HEARING DATE: November 3, 2022

TO: Planning & Zoning Commission

SUBJECT: Prairiefire
H-2022-0053

Annexation of 3.16 acres of land with an R-8 zoning district; and preliminary plat consisting of 22 building lots and 1 common lot on 3.16 acres of land in the R-8 zoning district for Prairiefire Subdivision.

B. Preliminary Plat (dated: 6/15/22)

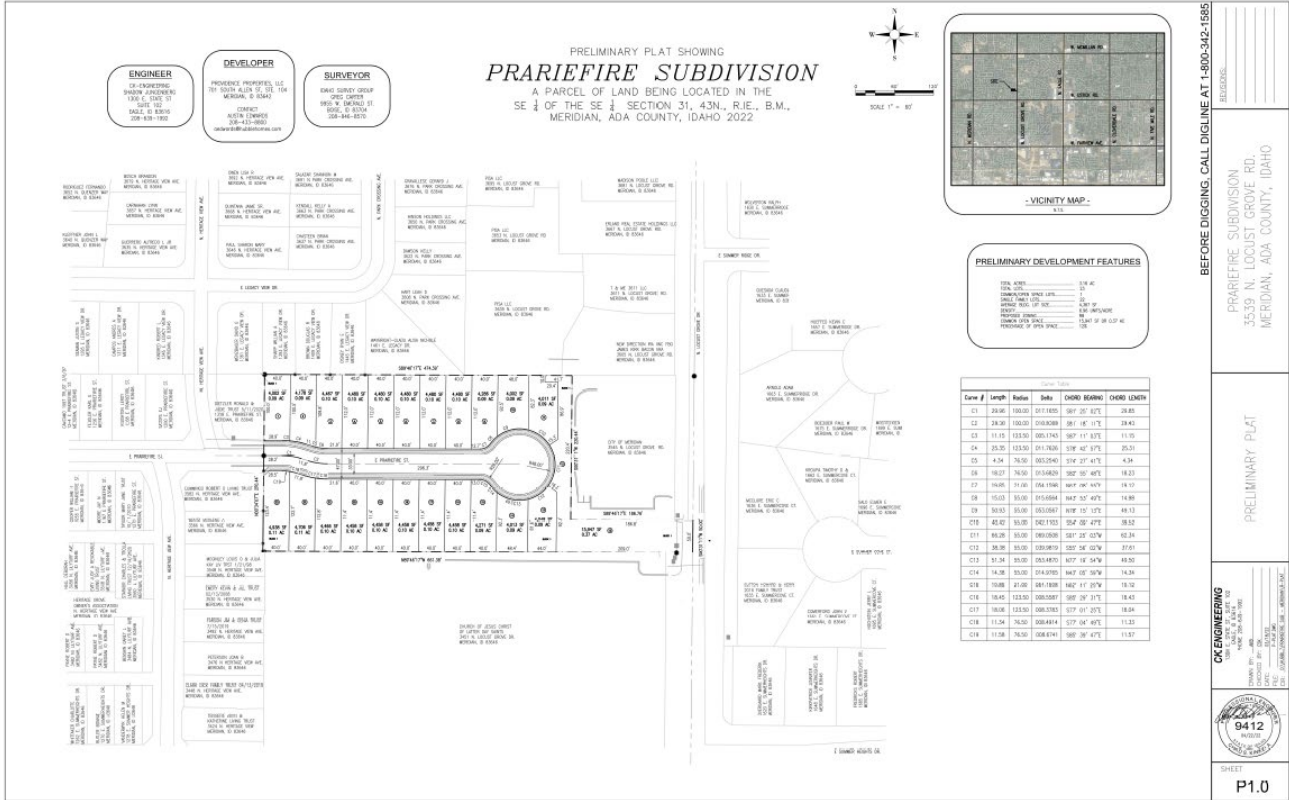
Staff recommends that the applicant remove Lot 11, Block 1 along the northern property boundary so the lots can be widened for a better transition and provide more visibility on the pathway connection to the commercial development.

Staff recommends that the applicant remove Lot 11, Block 1 along the northern property boundary. The micropath connection on the northern portion of the common lot adjacent to the commercial development is hidden behind Lot 11, Block 1 creating a potential safety issue for

2. The final plat shall include the following revisions:
 - a. Remove Lot 11, Block 1 to increase the size of all lots along the northern property boundary to provide a better-quality transition with the existing homes in the Quenzer Commons Subdivision and increase visibility on the micropath connection to the commercial development to the north.

OVERALL LANDSCAPE PLAN

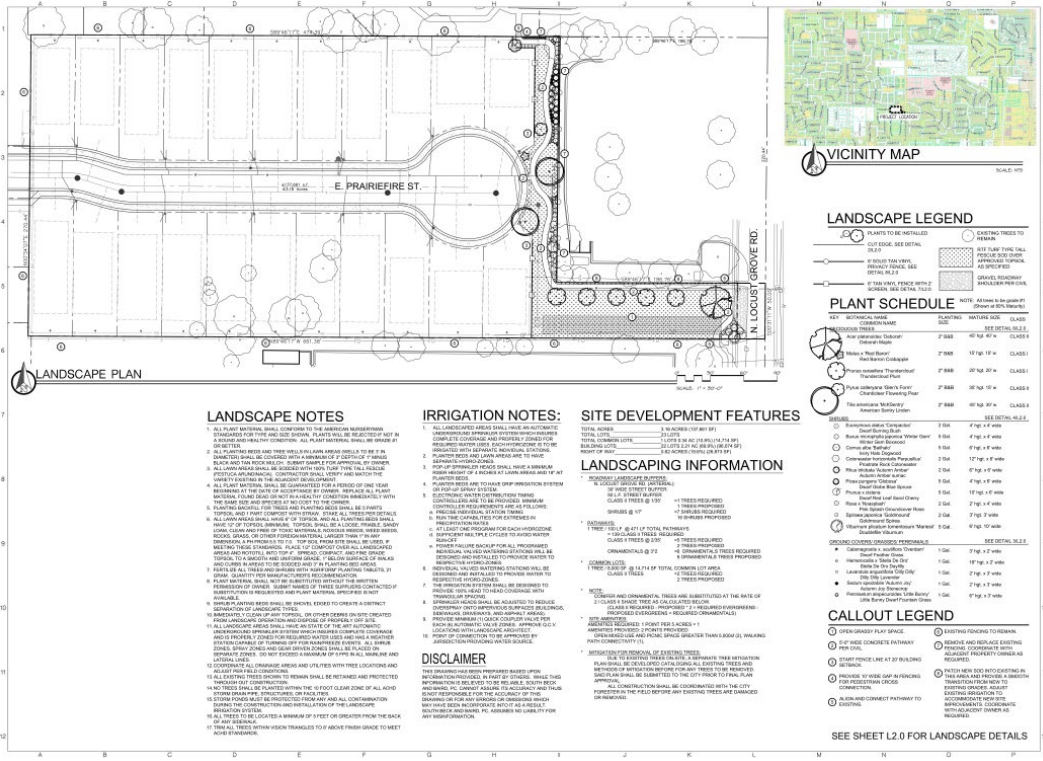
Landscaping (UDC 11-3B): A 25-foot wide buffer is required along material roads per UDC Table [11-2A-6](#). Common open space landscaping is proposed as shown on the landscape plan in Section VIII.C. All micro-pathways shall meet the requirements of UDC 11-3B including landscape strips of at least 5-foot in width on either side and one tree per 100 linear feet per the standards listed in UDC [11-3B-12C](#); **the landscape plan should be revised accordingly.**

3. The landscape plan submitted with the final plat shall include the following revisions:
 - a. Depict landscaping along the micropath in accord with the standards listed in [UDC 11-3B-12C](#).

- b. Remove Lot 11, Block 1 along the northern property boundary so the lots can be widened for a better transition and provide more visibility on the pathway connection to the commercial development.

- c. Include mitigation calculations on the plan for existing trees that are proposed to be removed in accord with the standards listed in UDC [11-3B-10C.5](#). The Applicant shall coordinate with the City Arborist (Kyle Yorita kyorita@meridiancity.org) to determine mitigation requirements *prior* to removal of existing trees from the site.
